ADMINISTRATIVE AMENDMENT	
FILE #:	PROJECT #:
APPROVED BY	DATE

NEW OFFICE/RETAIL

9001 HOLLY AVENUE, NE ALBUQUERQUE, NM

DRAWING NAME SITE DEVELOPMENT PLAN FOR BUILDING **PERMIT**

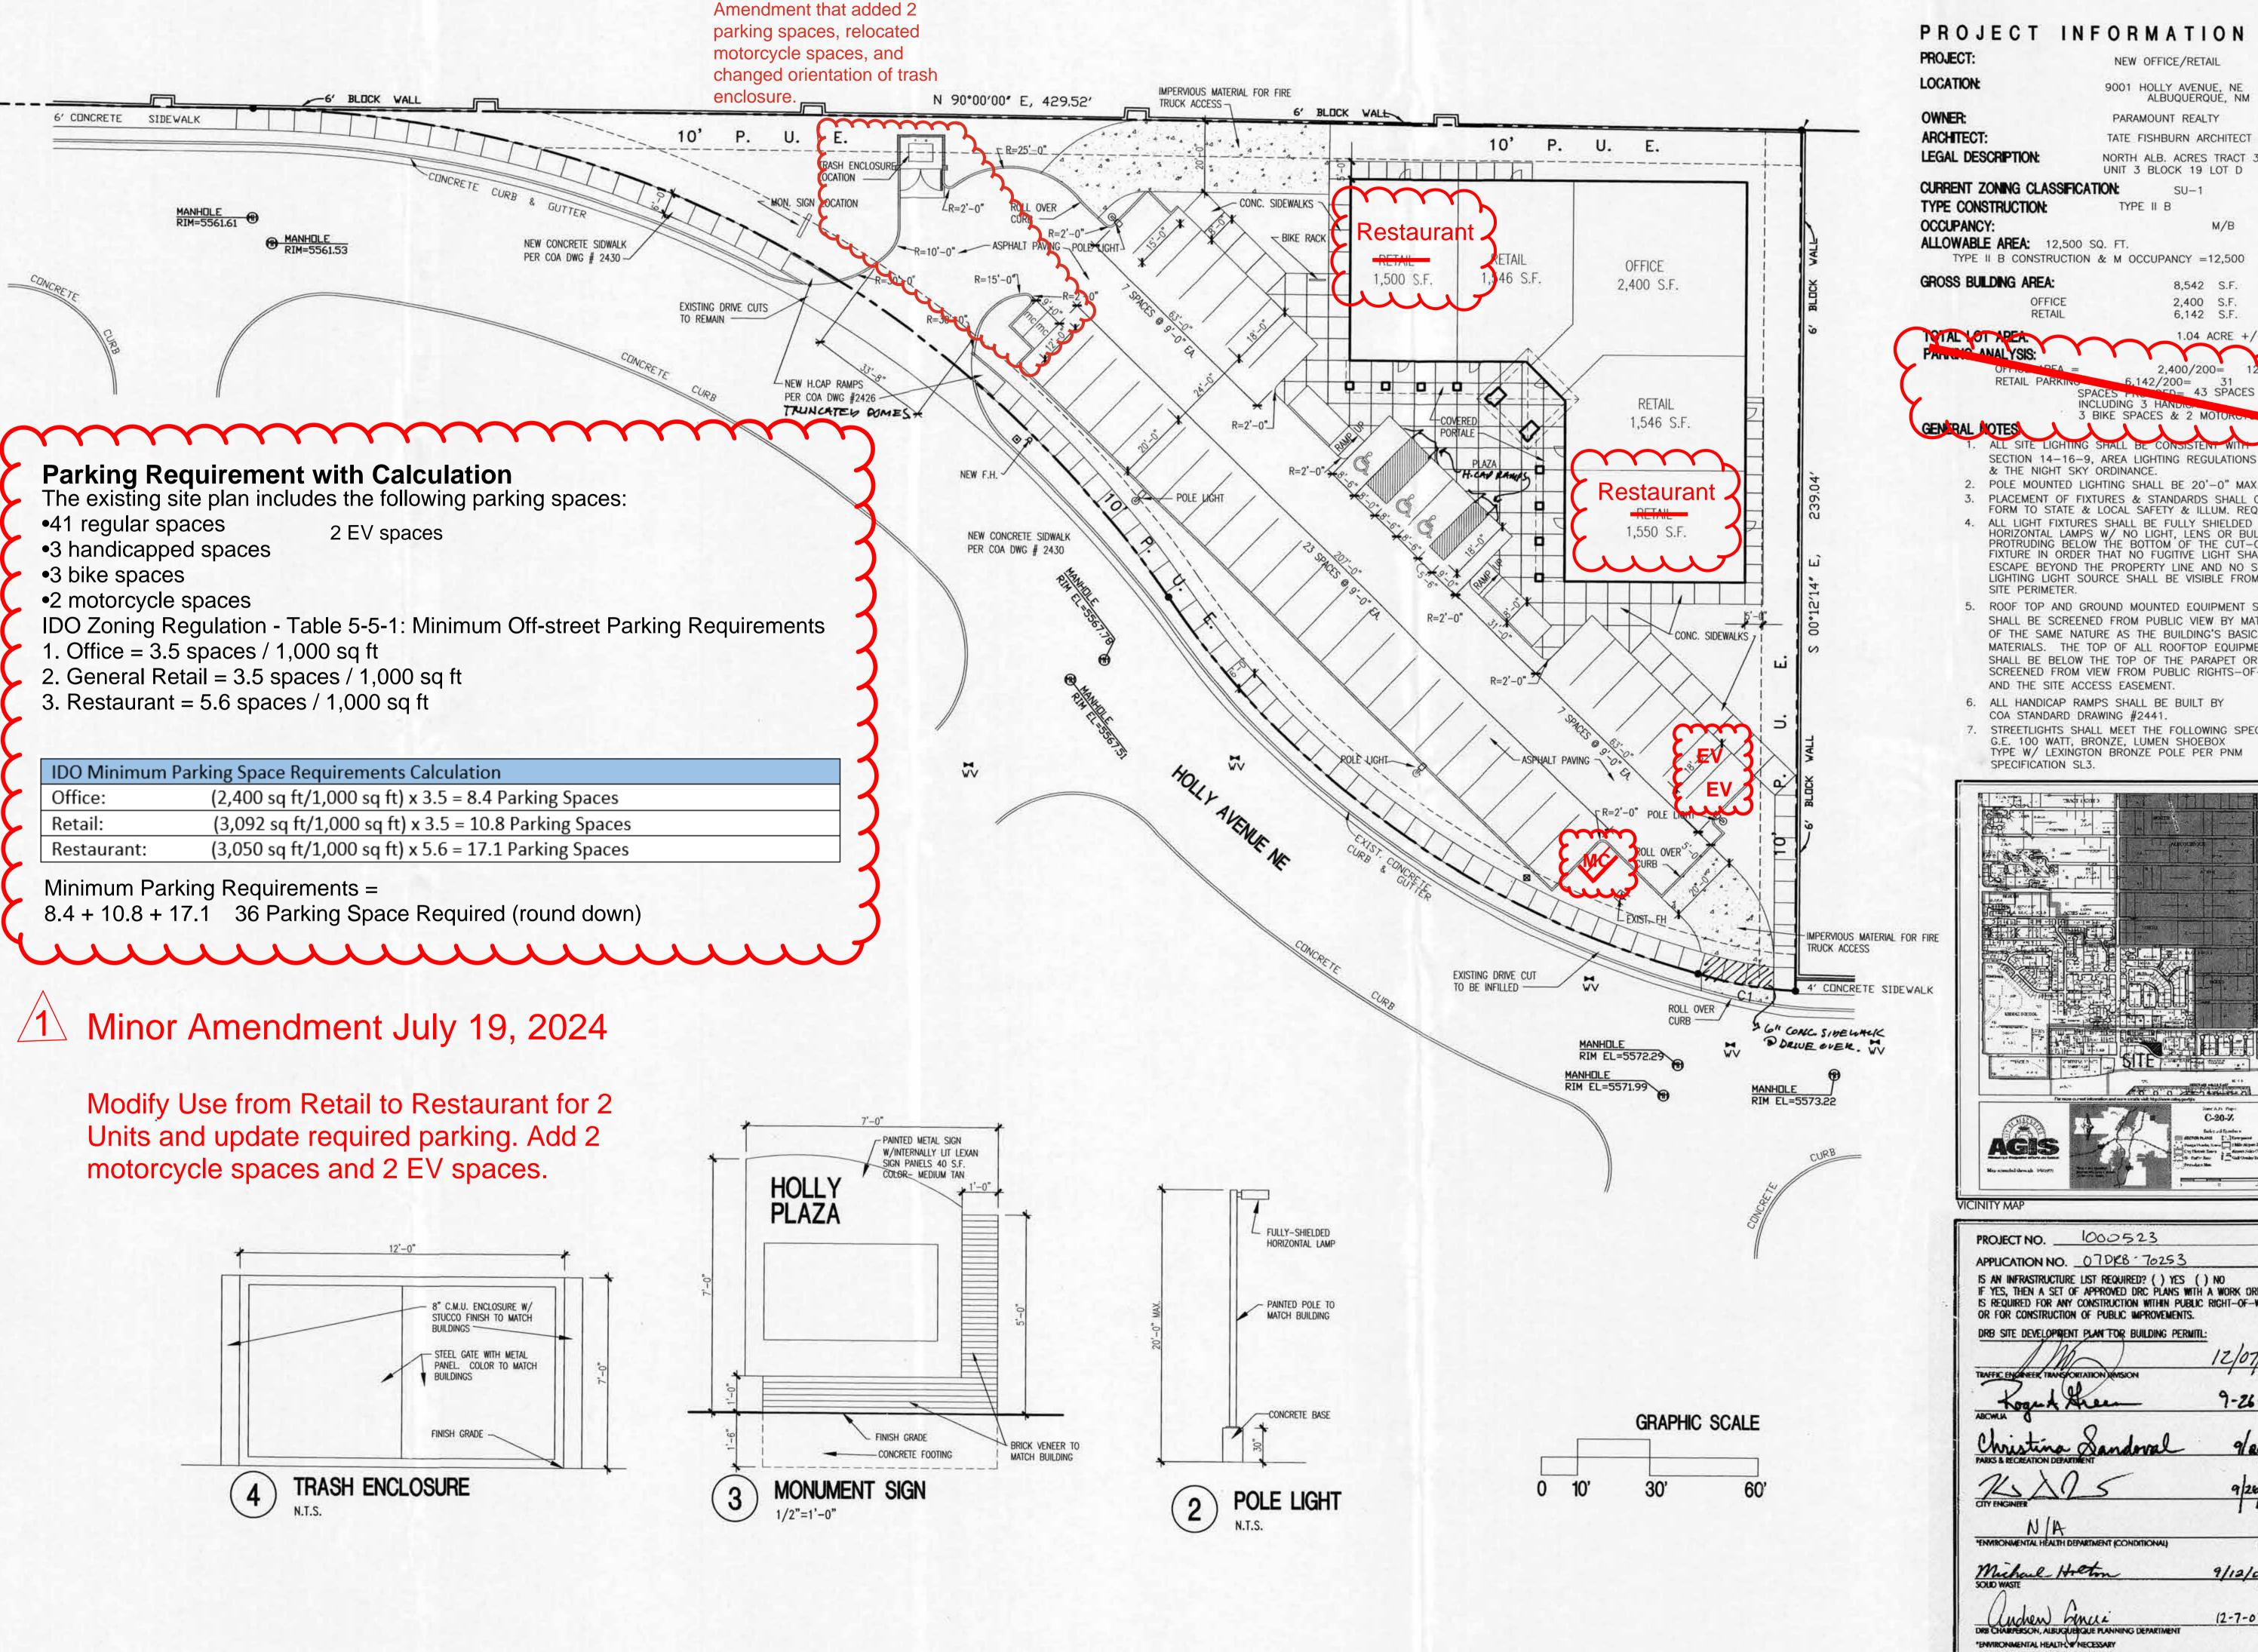
Hydrology Condition of Approval:

Developer must install a waterblock to control the runoff to or from the dumpster area.
